Discretionary Review Abbreviated Analysis

Date: September 12, 2016
Case No.: **2015-014114DRP**
Project Address: **245 Euclid Avenue**
Permit Application: 2015.10.02.8734
Zoning: RH-1 (Residential, House, One-Family)
40-X Height and Bulk District
Block/Lots: 1069/035
Applicant: Tai Ikegami
Feldman Architecture
1005 Sansome Street, Suite 240
San Francisco, CA 94111
Staff Contact: Chris May – (415) 575-9087
christopher.may@sfgov.org
Recommendation: **Do not take DR and approve as proposed**

A2.3
SHEET

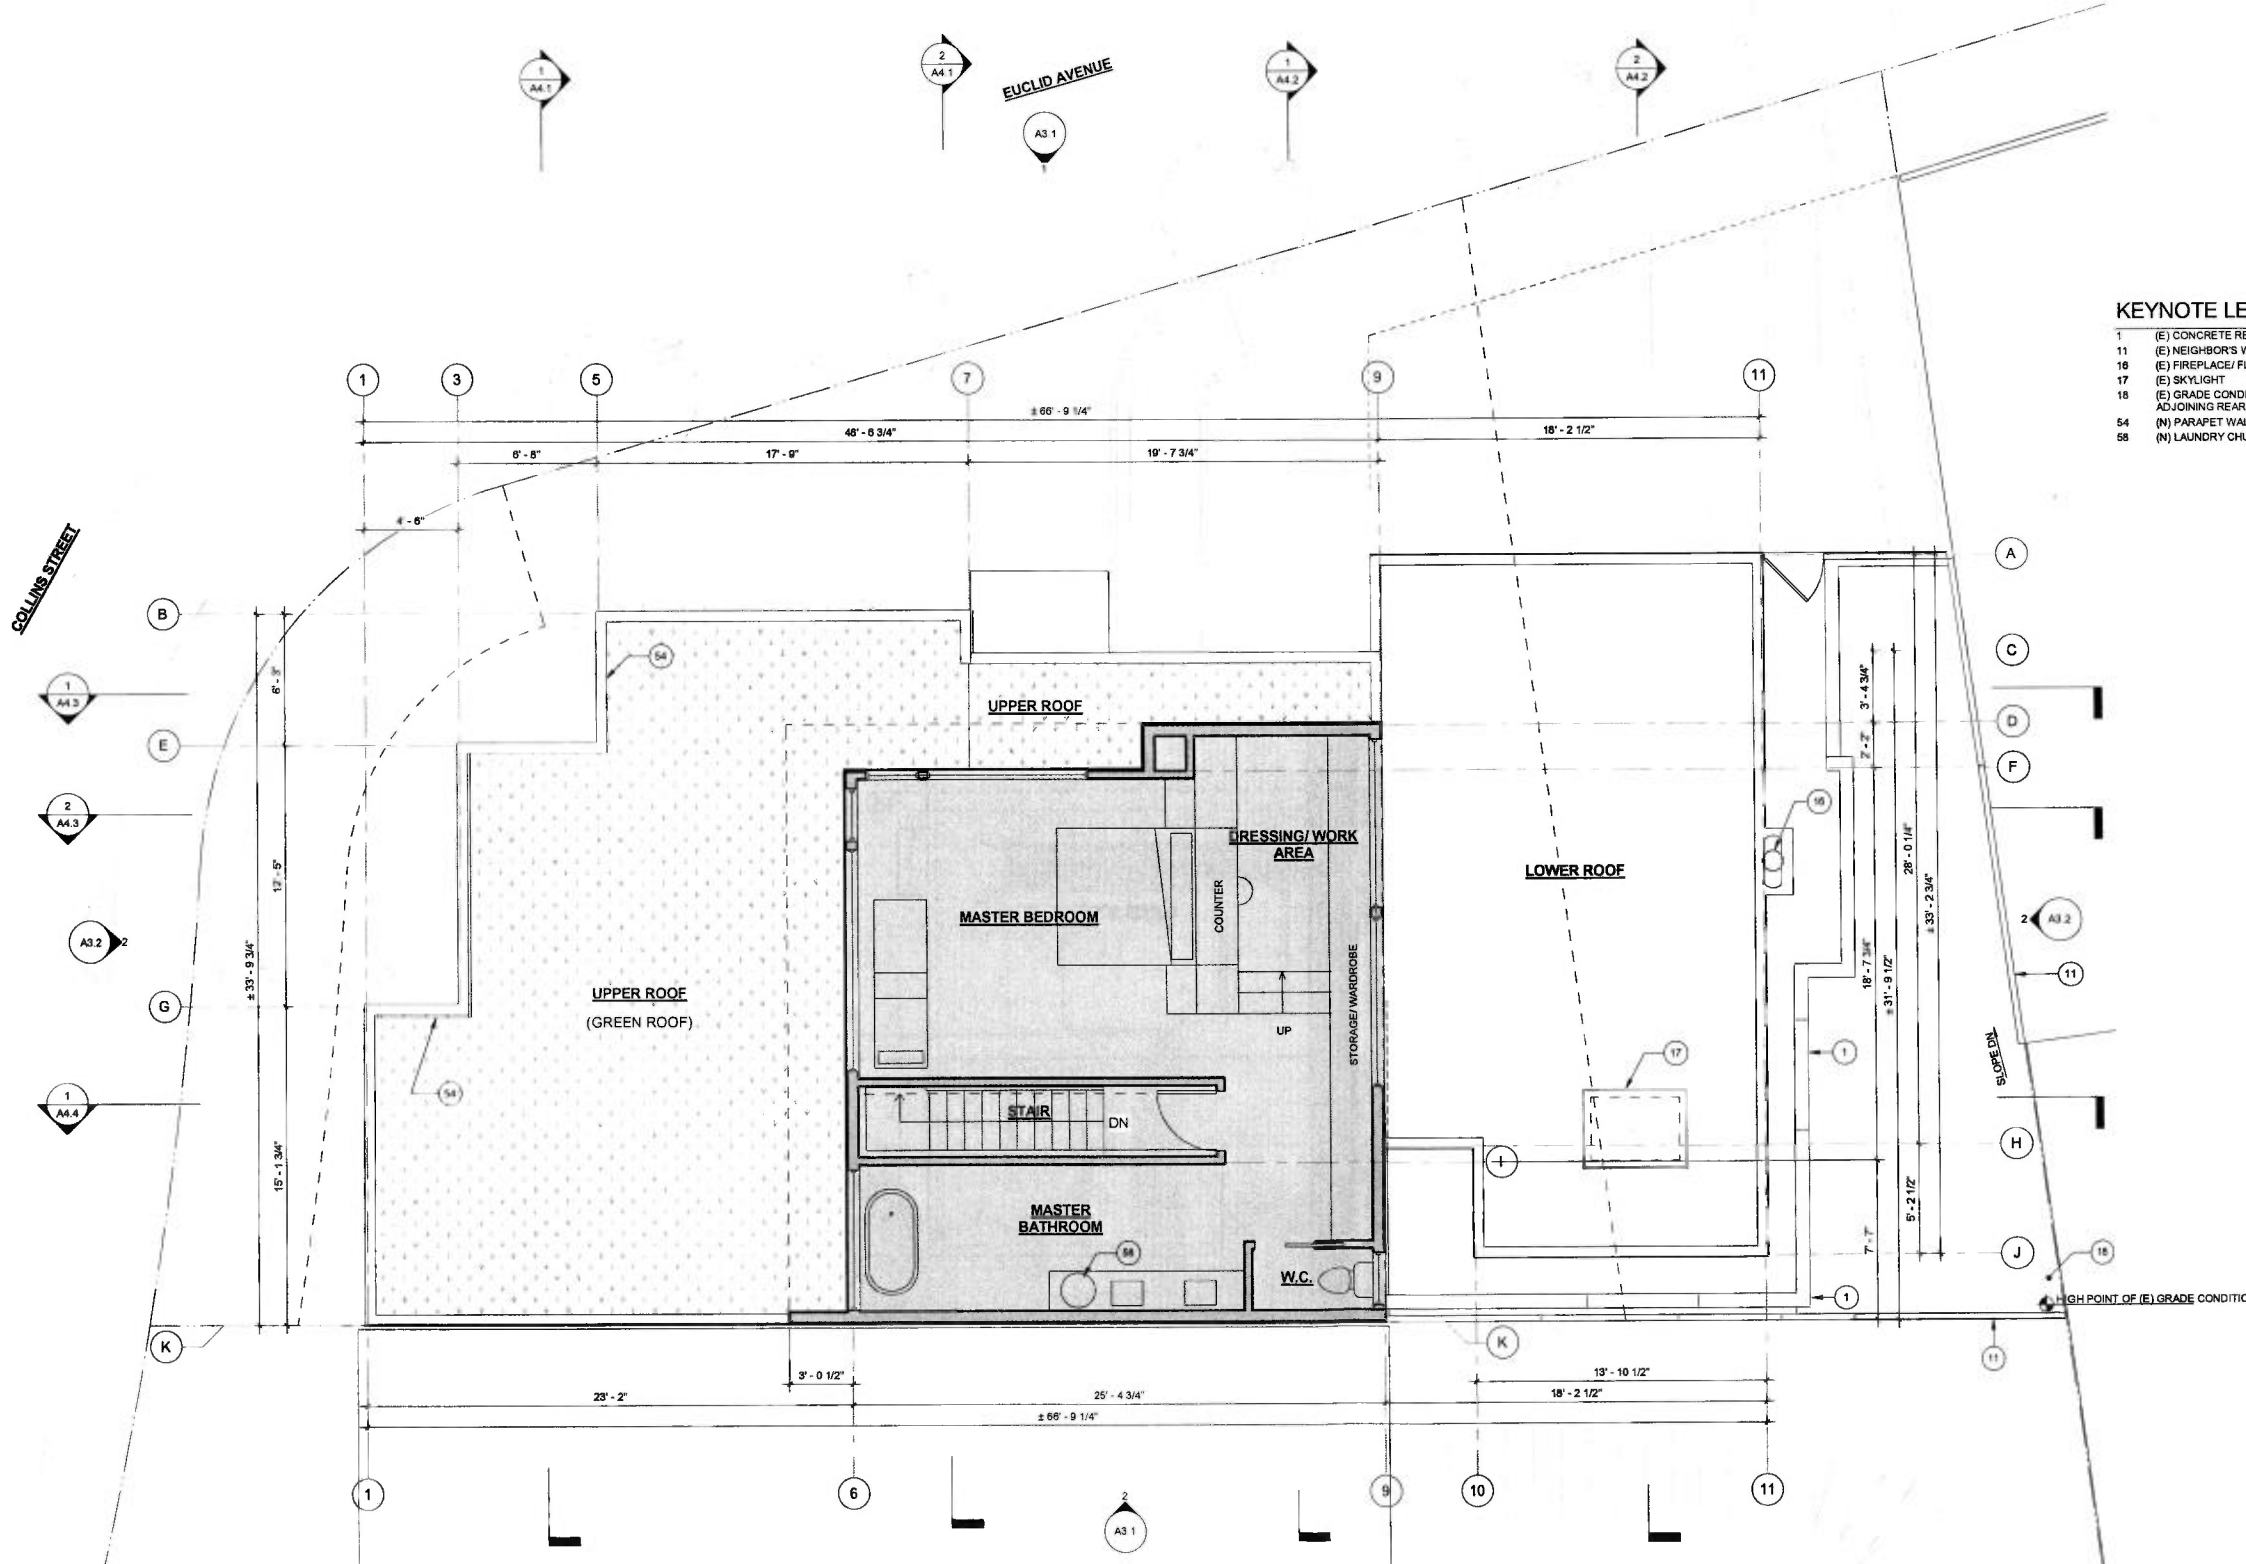
The Residential Design Guidelines provide “Create a prominent building entrance by notching the corner.” (Ex. B, p. 19) The subject property has a notched corner. (Ex. D, photos) However, the proposal would install in that notched corner a bathroom for the existing guest bedroom in the garage. (Ex. A, Sheet A2.1, point 28, outline of existing building) The Commission should prohibit filling in the notched corner with a bathroom so that the existing detailing of this prominent corner building is maintained. A fourth bathroom to be built in the notch is not needed. The project would have 3 other bathrooms. (Ex. A, Sheets A2.1, 2.2 and 2.3)

D3.1
SHEET

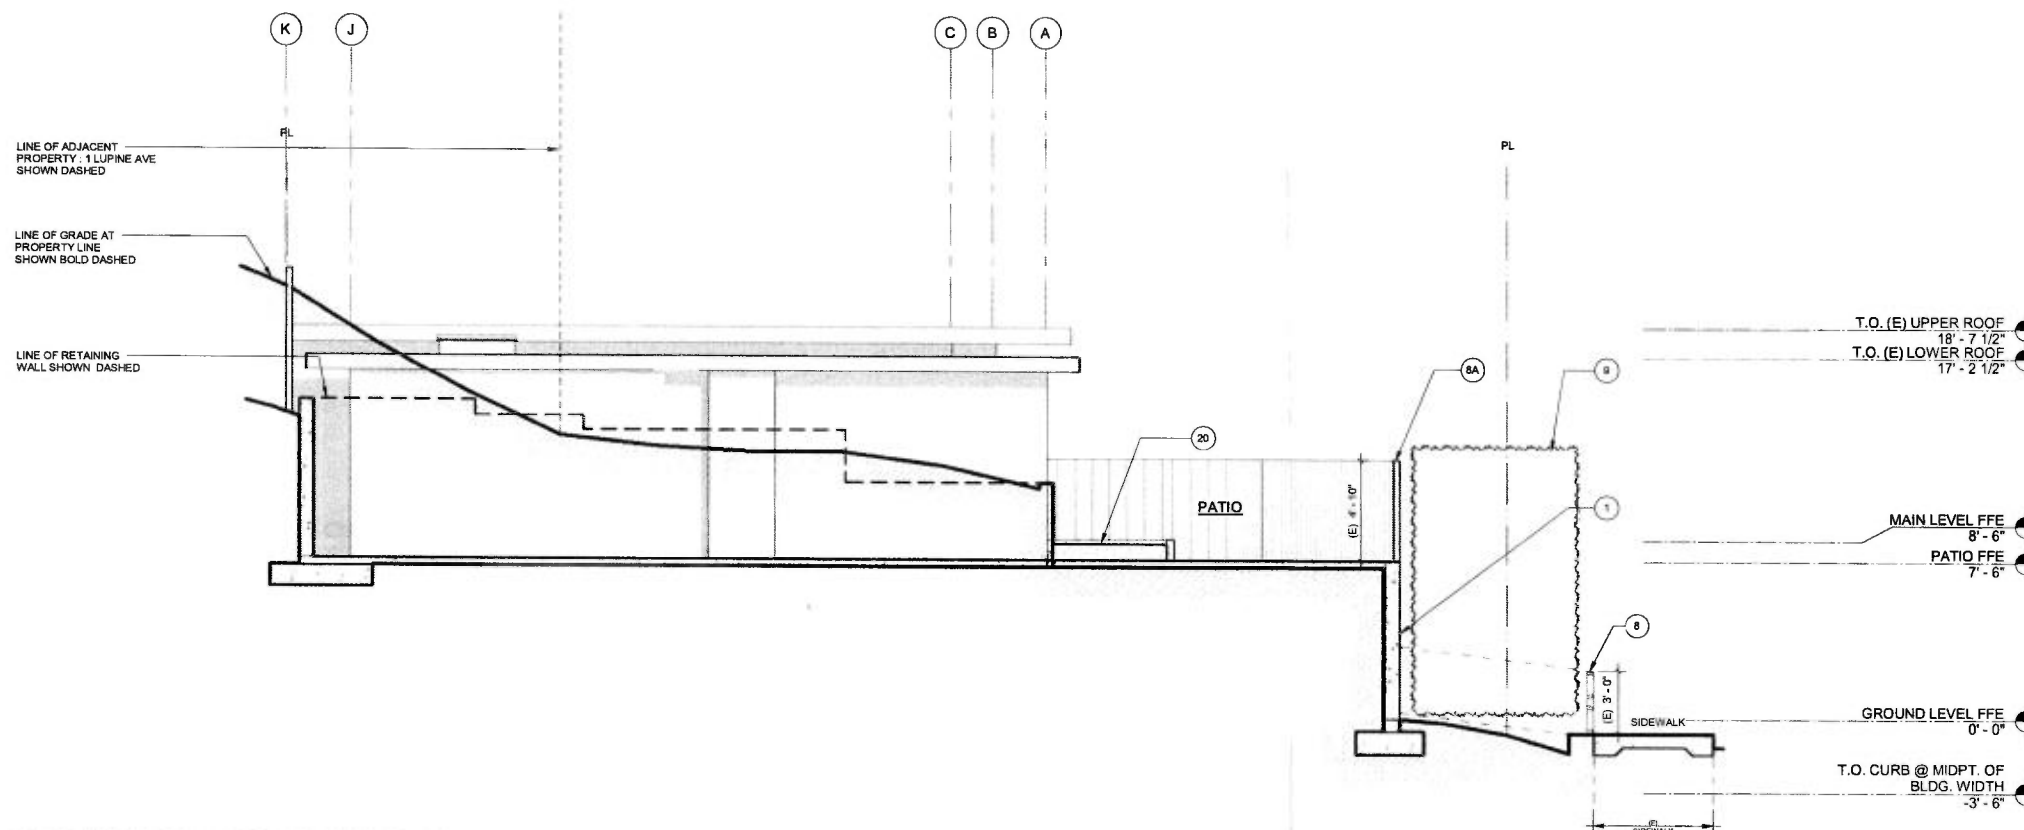
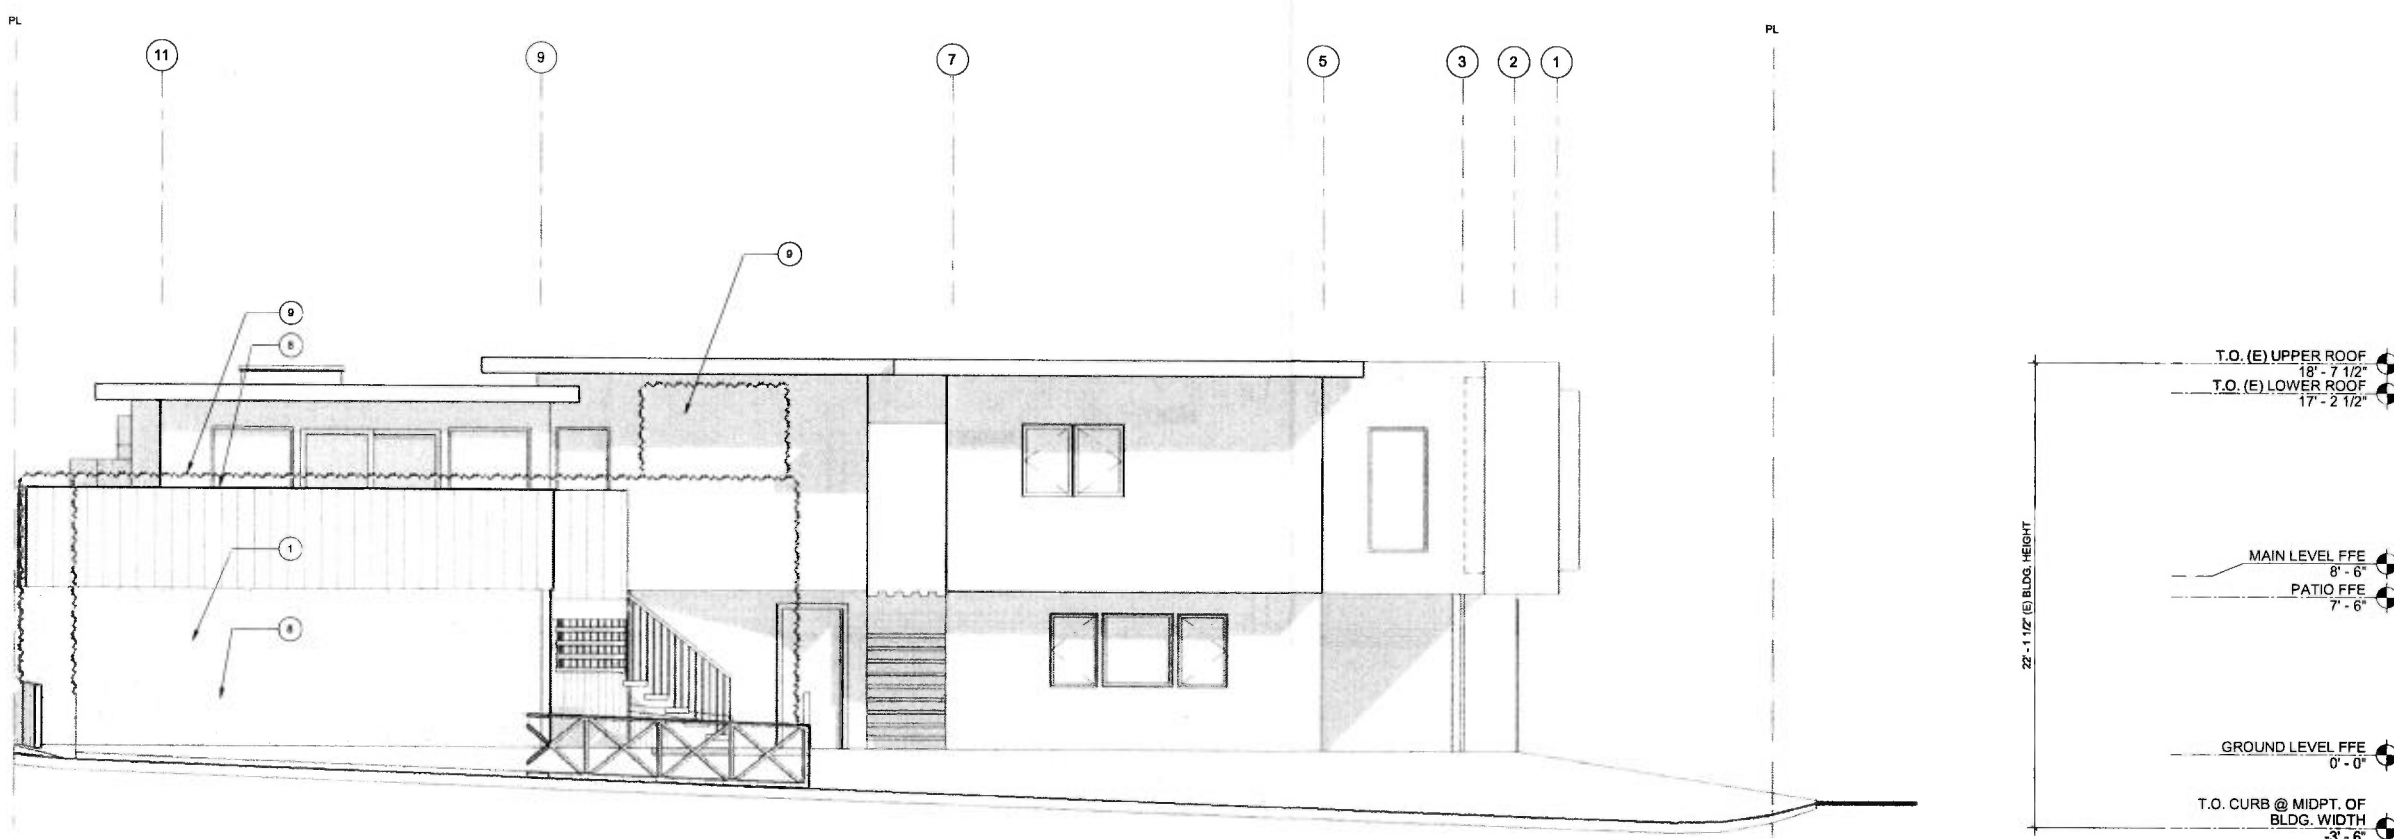
Under Planning Code §136(c)(24(A) the “floor of a deck shall not exceed a height of three feet above grade at any point in the required open area.” Sheet D3.1 shows the elevation of the existing patio as 7-feet, 6-inches. (Ex. A) This is the same elevation as the proposed patio extension, which would require a Variance. (Ex. A, Sheet A3.1; Ex. C, App. for Variance, p. 8) The planner Christopher May told Ms. Devincenzi on May 4, 2016 that there is no permit for construction of the existing “terraced patio.” A portion of the patio juts above grade and is supported by a column, which is clearly not original construction. There is also no building permit for construction of the horizontal wooden board fence that is atop the retaining wall, which extends to elevation 11-foot, 5 inches. The Commission should deny further expansion of this illegal nonconforming patio or deck structure and nonconforming use and its associated illegal nonconforming retaining wall/fence.

Moreover, the plans show that there is no grade change between the existing patio and the proposed expanded patio. Sheets D3.1 and A3.1 show that both the existing patio and the proposed expanded patio would be at the same grade. (Ex. A) Thus, even if a Variance is granted for the expanded portion of the patio, the existing portion of the “terraced patio” would still be an illegal nonconforming structure and use. A Variance was not sought for the grade change needed to legalize the existing illegal nonconforming “terraced patio” or its extension that is supported by a column. Expansion of such a nonconforming structure or use would violate Planning Code §§ 180, 181, and 188.
